STAFF RECOMMENDATION
1703 Forrest Avenue
July 18, 2018

Application: New construction - addition
District: Lockeland Springs-East End Neighborhood Conservation Zoning Overlay
Council District: 06
Map and Parcel Number: 08310025600
Applicant: Christopher Milfred
Project Lead: Melissa Sajid, melissa.sajid@nashville.gov

Description of Project: The application is to construct a new rear addition to a one-story historic house. **Recommendation Summary:** Staff recommends approval of the project with the following conditions: 1. Staff shall review and approve the materials for the siding, trim, roof color, windows, door, and garage door prior to purchase and installation; 2. Siding shall have a maximum reveal of five inches (5”) and shall be smooth faced; and 3. The HVAC unit, if relocated, shall be at or behind the midpoint of the building. With these conditions, staff finds that the addition is compatible with the historic house and meets the design guidelines for the Lockeland Springs-East End Neighborhood Conservation Zoning Overlay.	**Attachments** **A:** Photographs **B:** Site Plan **C:** Elevations

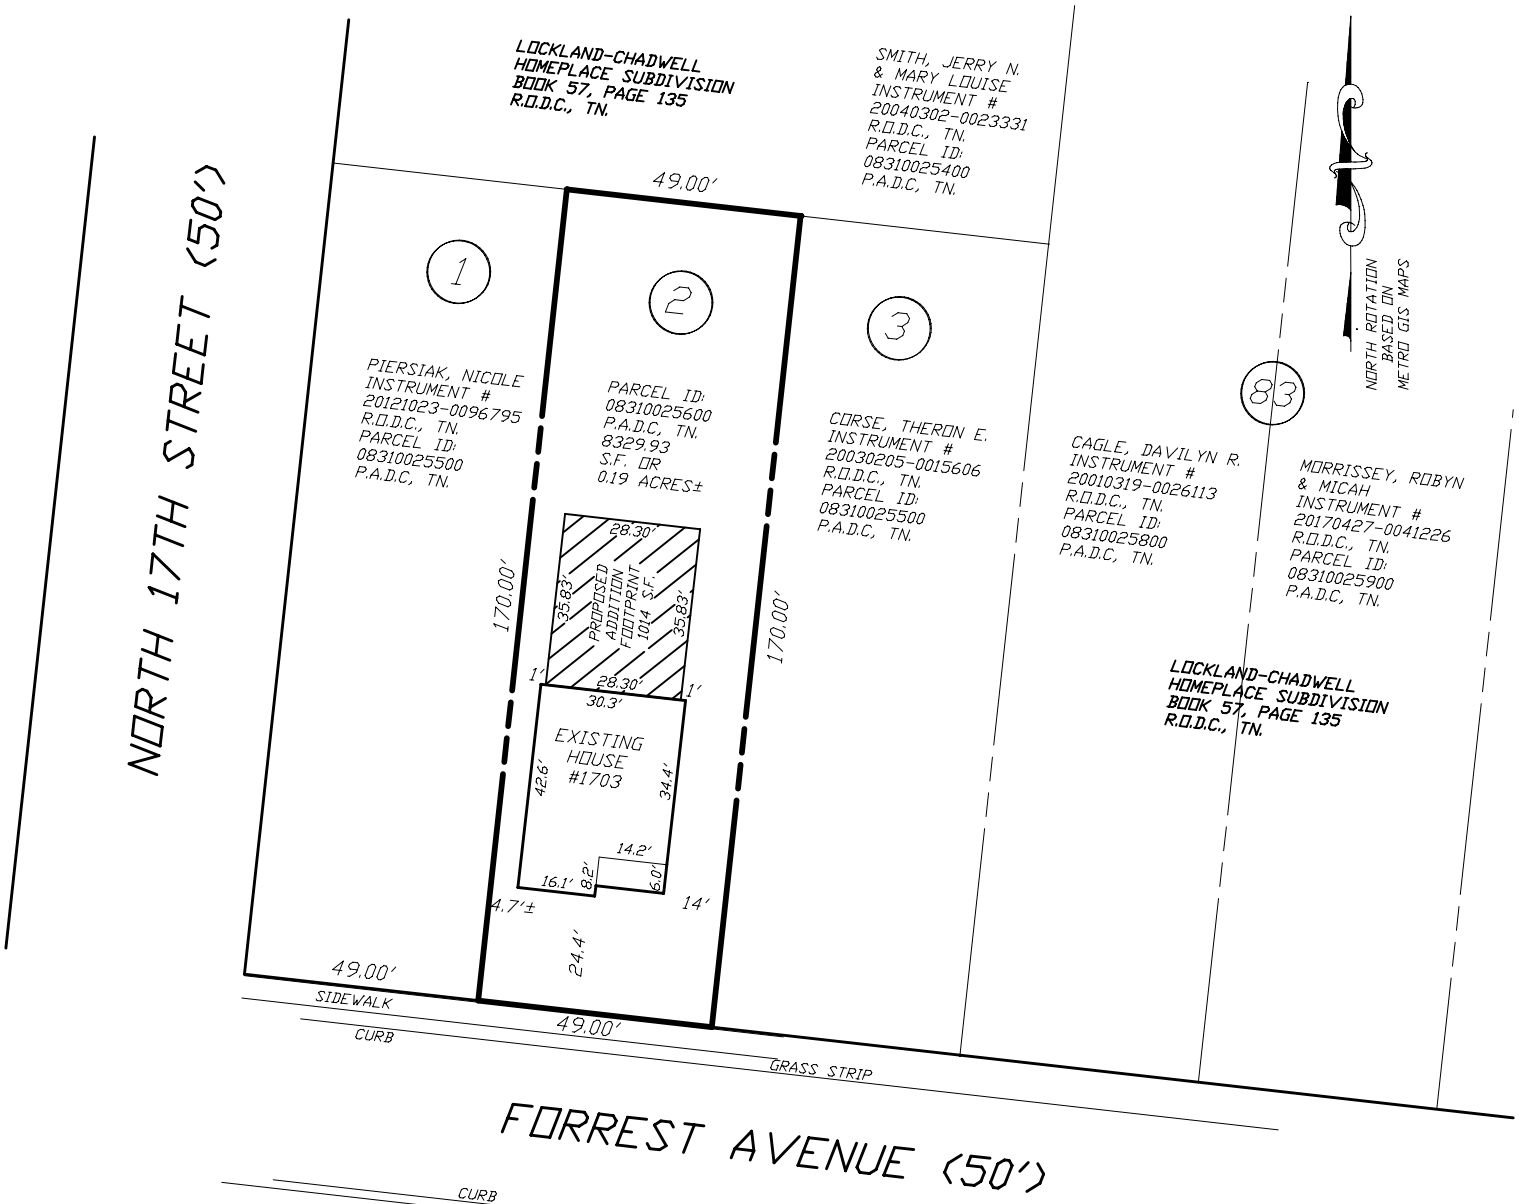
Setbacks: The new addition meets all setbacks required by the base zoning. The addition is located approximately sixty-eight feet (68') from the rear property line, fourteen feet (14') from the right side property line, and seven feet (7') from the left side property line.
Lockeland Springs – East End design guidelines.

MAIN FLOOR PLAN

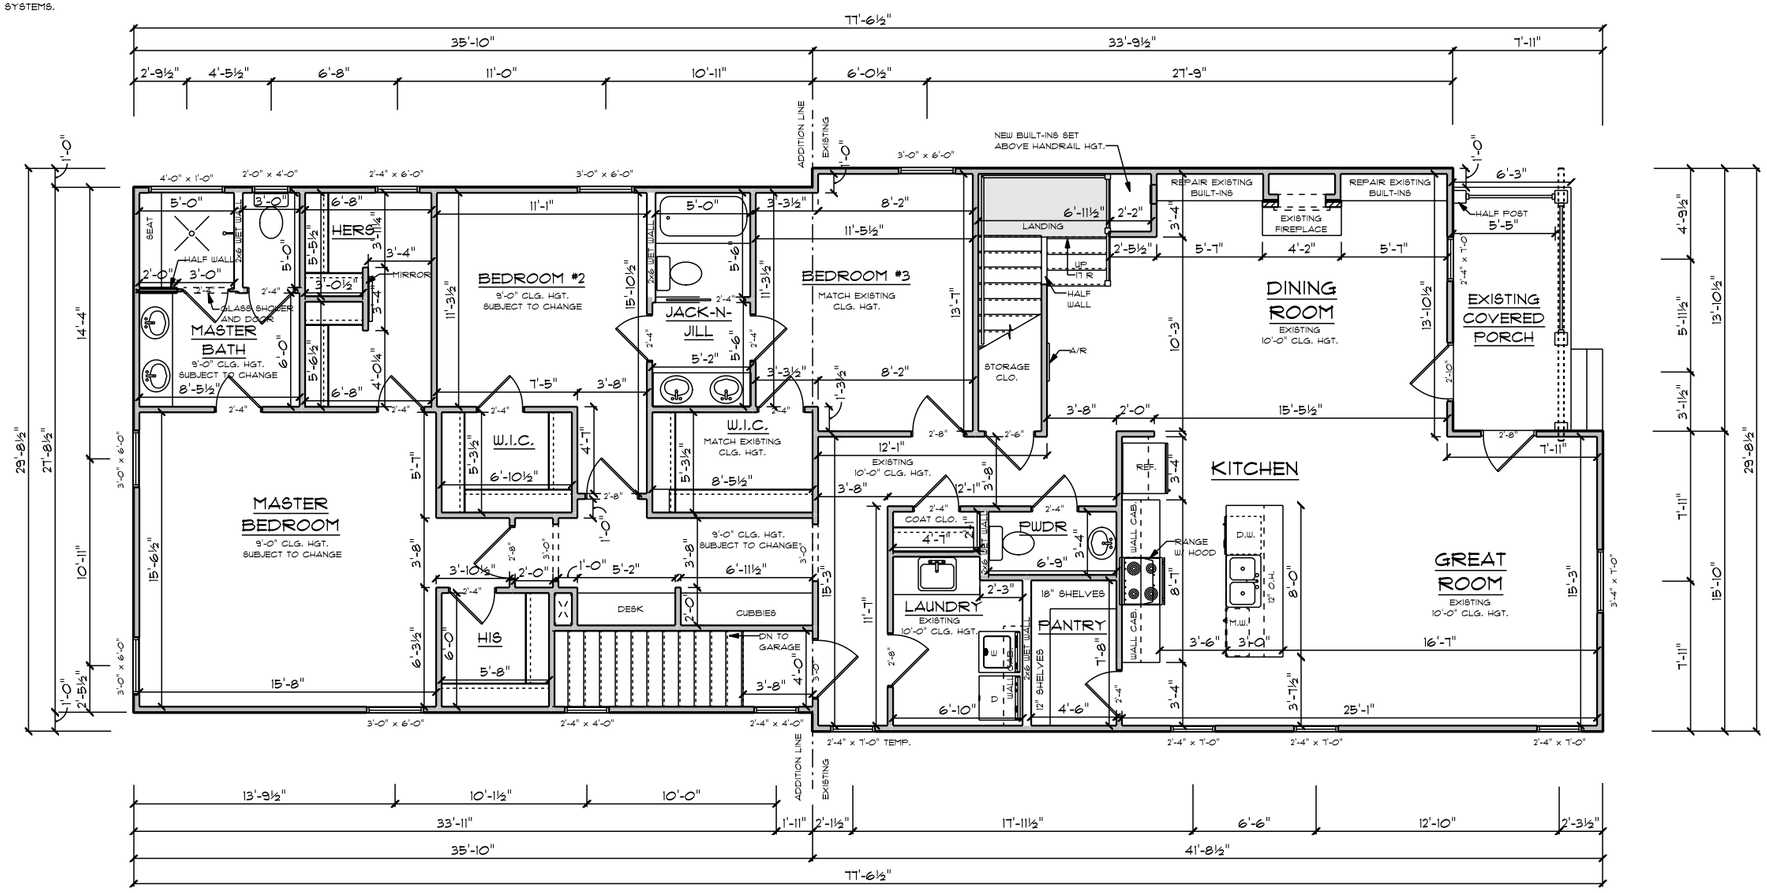
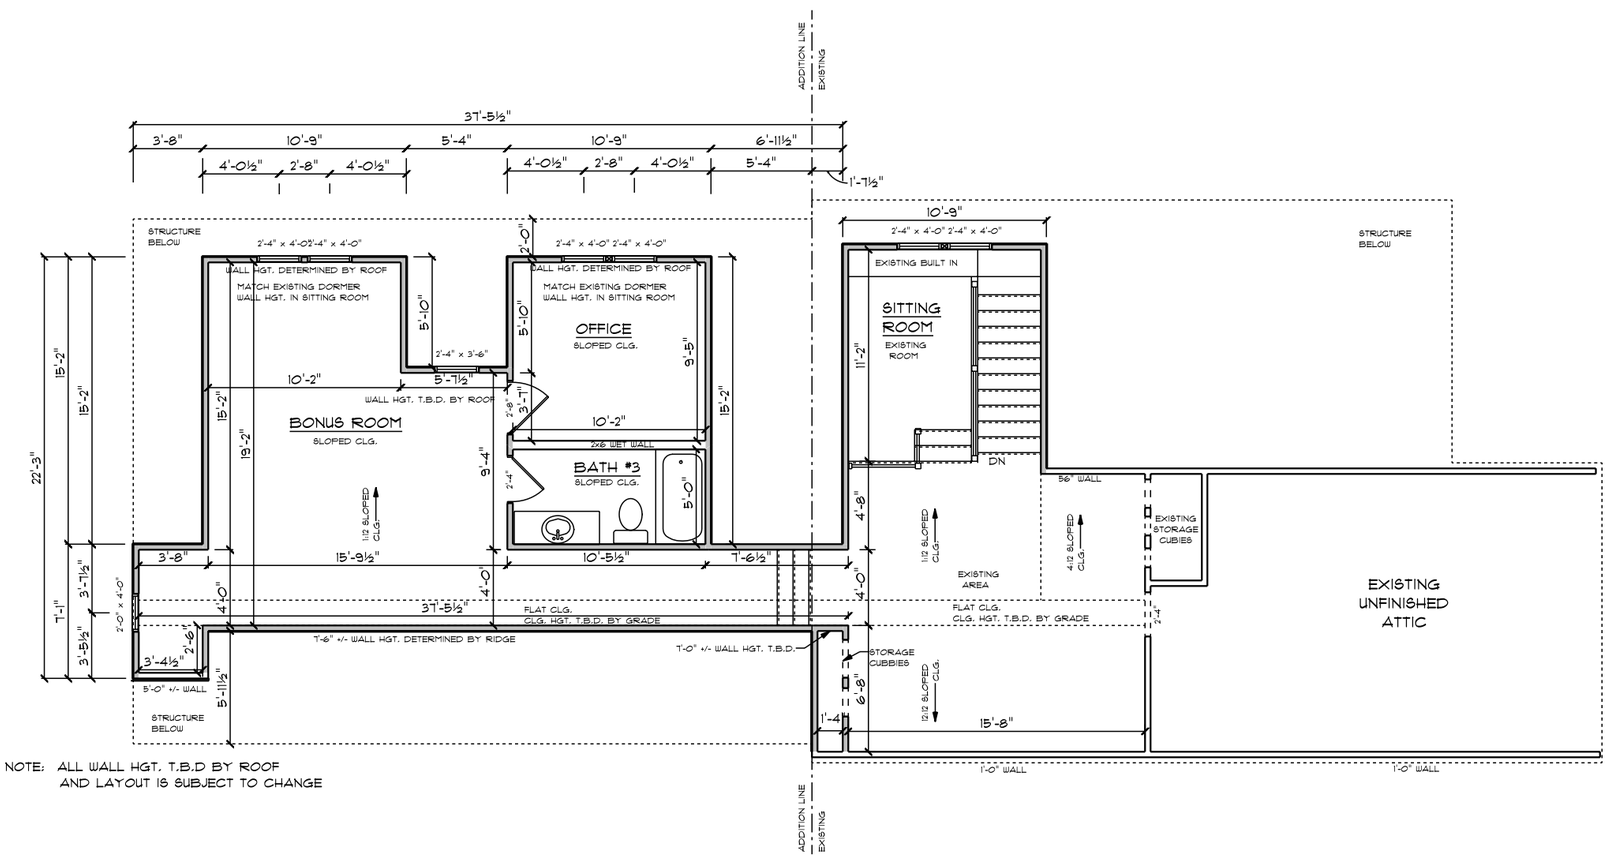
The proposed additional rear footprint is approximately one thousand and forty-four feet (1044 sq. ft.), compared to the existing footprint which is approximately one thousand, one hundred, and ninety-two square feet (1192 sq. ft.). The addition does not more than double the footprint of the existing house and adds thirty-six feet (36') to the depth of the building.

Since the rear addition is neither taller nor wider than the existing house and does not more than double the existing footprint, staff finds that the rear addition is compatible in scale to the building and that the project meets Section II.B.10.a of the design guidelines.

FRONT ELEVATION

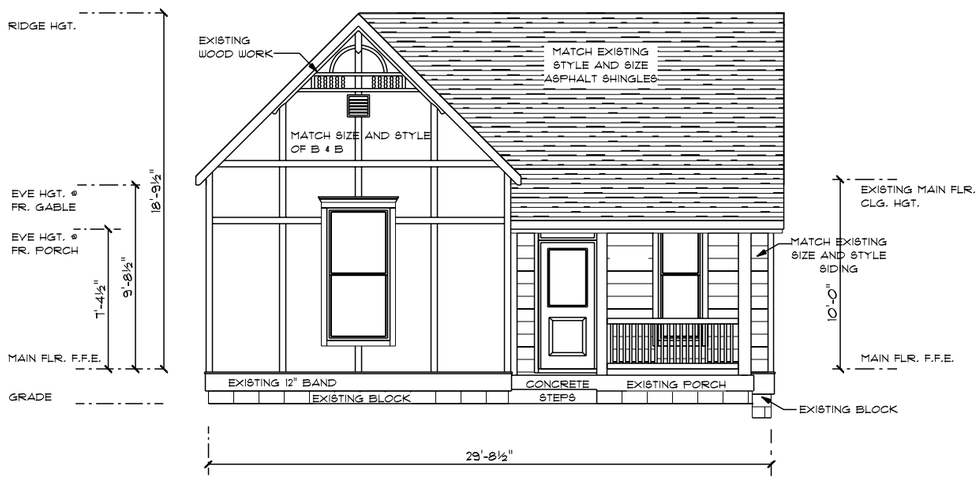
Height & Scale: The new construction is located at the rear of the structure, in accordance with design guidelines. The foundation and ridge heights of the addition are the same as the existing rear addition, and the proposed eave height will be approximately one foot (1') taller.

The plan indicates that the addition will be clad with siding with an eight inch (8") reveal. Additional information is needed on the type of siding proposed, and staff finds that the reveal should be a maximum of five inches (5"). Incorporating siding with a maximum reveal of five inches (5") is closer to what is seen on the historic house and also meets the design guidelines. Additional information is also needed to assess the materials for the trim, roof color, windows, door, and garage door. With the condition that staff review the materials for the siding, trim, roof color, windows, door, and garage door prior to purchase and installation, staff finds the proposed materials to be appropriate and that the project meets section II.B.10.a of the design guidelines.

Proportion and Rhythm of Openings**:** The windows on the proposed addition are generally twice as tall as they are wide, thereby meeting the historic proportions of openings. The right side elevation of the addition includes a smaller horizontal window that could be appropriate as it is located on the side façade near the rear of the house. Staff finds the proportions and rhythm of openings to be appropriate and to meet section II.B.10.a and II.B.10.b of the design guidelines.

1. Staff shall review and approve the materials for the siding, trim, roof color, windows, door, and garage door prior to purchase and installation;
2. Siding shall have a maximum reveal of five inches (5”) and shall be smooth faced; and
3. The HVAC unit, if relocated, shall be at or behind the midpoint of the building.

RIGHT ELEVATION

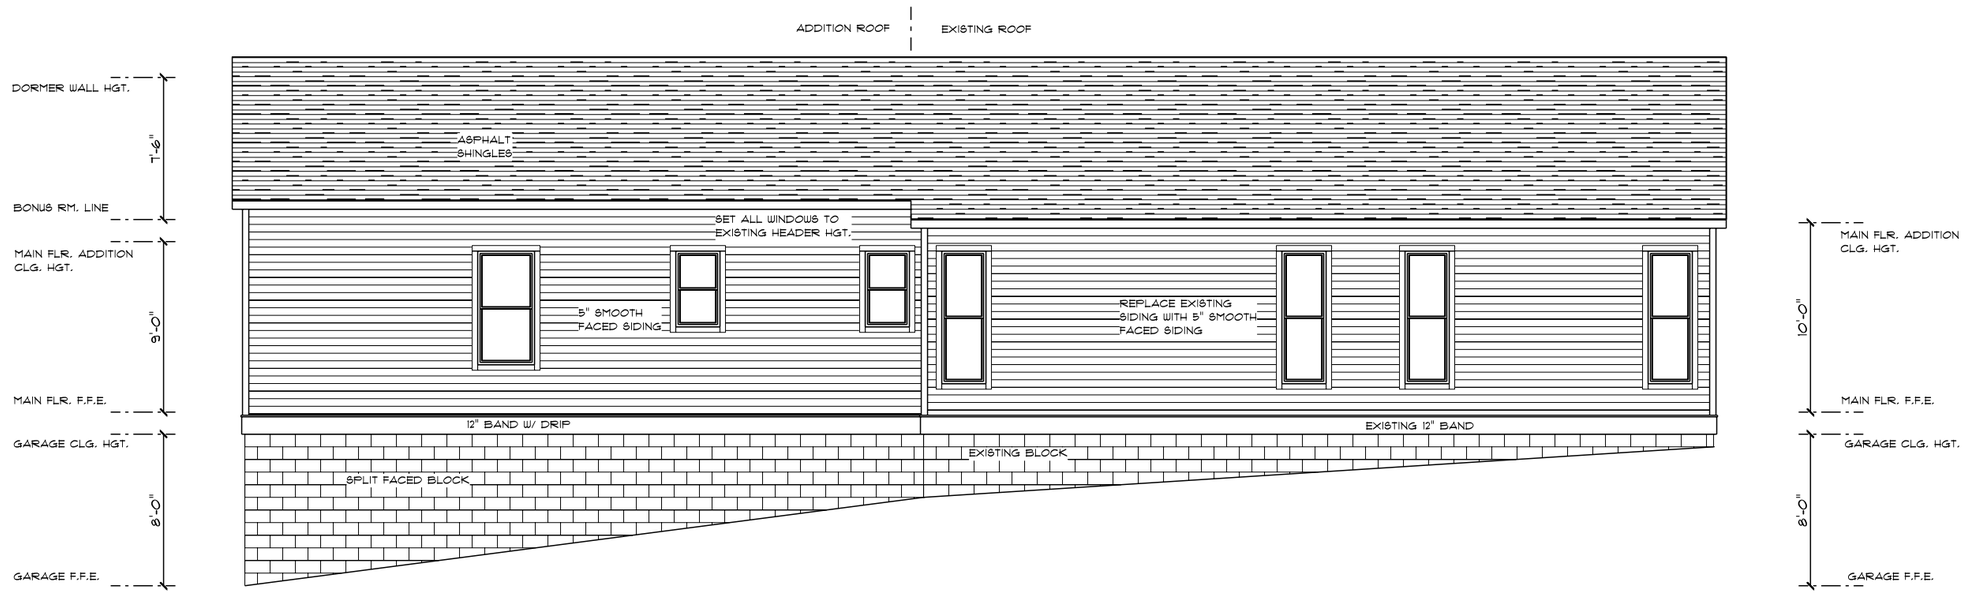
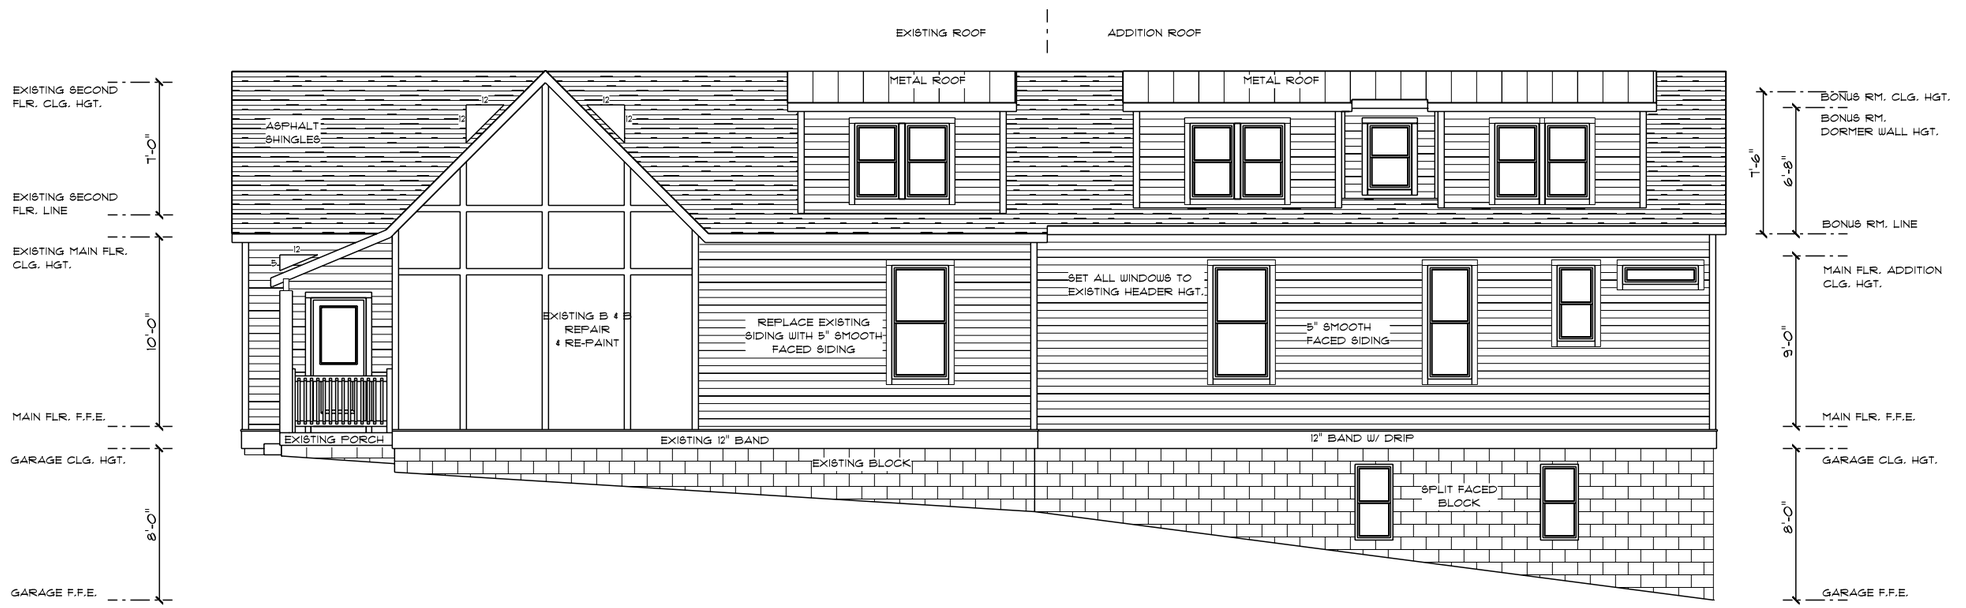
Roof form: The roof of the addition will be a rear facing gable, matching the form and pitch of the original roof. The request includes a lower sloped shed dormer on the right side façade. While the dormer is wide, it is located at the rear and not only be set in two feet (2') from the wall below but also an additional foot (1') from the existing side wall. So, in total, the new dormer will be set in three feet (3') from the existing side wall of the house. Staff finds the new roof forms are compatible with the roof of the existing house and that the project would meet section II.B.10.a of the design.
